TECH TIPS

1004

COACH MODEL	:	C2045 & T2100
DATE	:	02/03/2010
SUBJECT	:	HVAC Check Valve Change

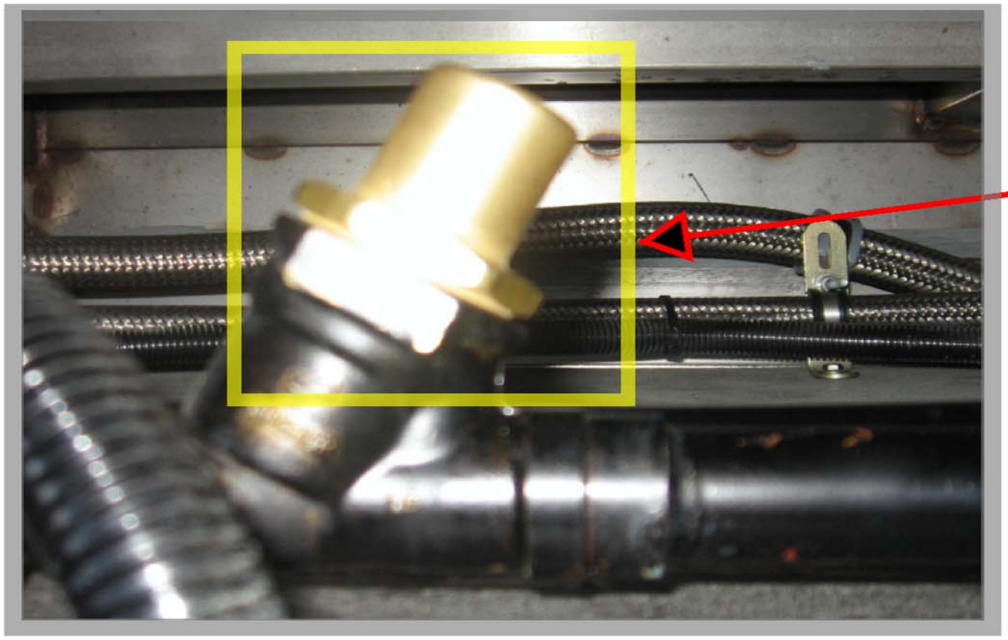
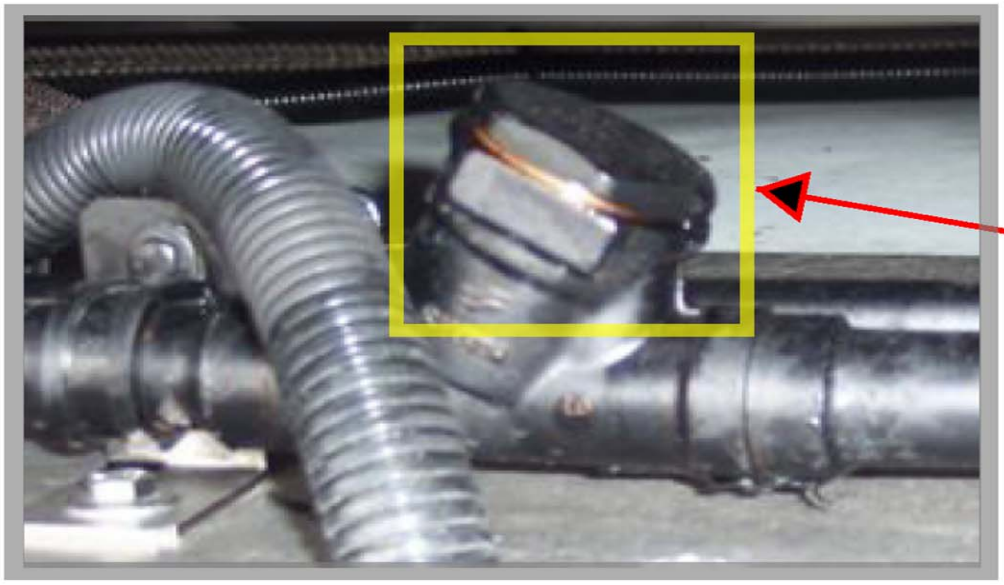
You can ID the new style check valve with the raised center on the cap

The old style has the flat cap

It has been noticed when a C or T coach is in A/C mode and the engine is at regular idle RPM's that the check valve behind the condenser may make a knocking noise. Check the system to verify the correct operating pressures and refrigerant level is ok. If noise still continues ,replacement of the check valve will be necessary

NEW
Part numbers
VH # 11184588
or Carrier #
14-00281-04
